General Electric Company 175 Curther Americe, San Jose, CA 95125 -

Subject: Submittal Supporting Accelerated ABWR Review Schedule - Chapter 3 Clarifications

ABWR Standard Plant

23A6100AE REV. B

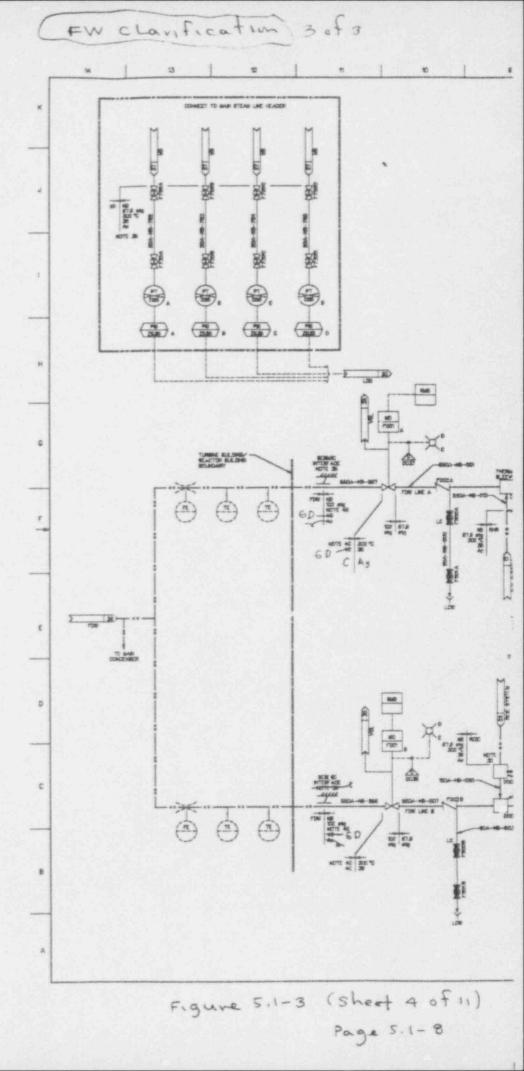
The feedwater piping consists of two 22-inch diameter lines from the feedwater supply header to the reactor. On each of the feedwater lines from the common feedwater supply header, there shall be a seismic interface restraint. The seismic interface restraint serves as the boundary between the Seismic Category I piping and the non-seismic pipings Downstream of the reismig interface costraine ubero is a conote manual, motor-operated valve powered by a non-safety-grade bus. These motor-operated valves serve as the shutoff valves for the feedwater lines. Isolation of each line is accomplished by two containment isolation valves consisting of one check valve inside the drywell and one positive closing check valve outside the containment (Figure 5.1-3). The closing check valve outside the containment is a spring-closing check valve that is held open by air. These check valves will be qualified to withstand the dynamic effects of a feedwater line break outside containment. Inside the containment, downstream of the inboard FW line check valve, there is a manual maintenance valve (B21-F005)

As discussed in Table 3.2-1 and shown in Figure 5.1-3 the feedwater piping is Quality Group A from the reactor pressure vessel out to and including the outboard isolation valve, Quality Group B from the outboard isolation valve to and including the seismie interface shut off restraint, and Quality Group D beyond the shutoff valve. The feedwater piping and all connected piping of 2-1/2 inchelarger nominal size is Seismic Category I only from the reactor pressure vessel out to, and including, the seismic interface restraint, shutoff valve

rshall be located close to

-which exists at the upstream end
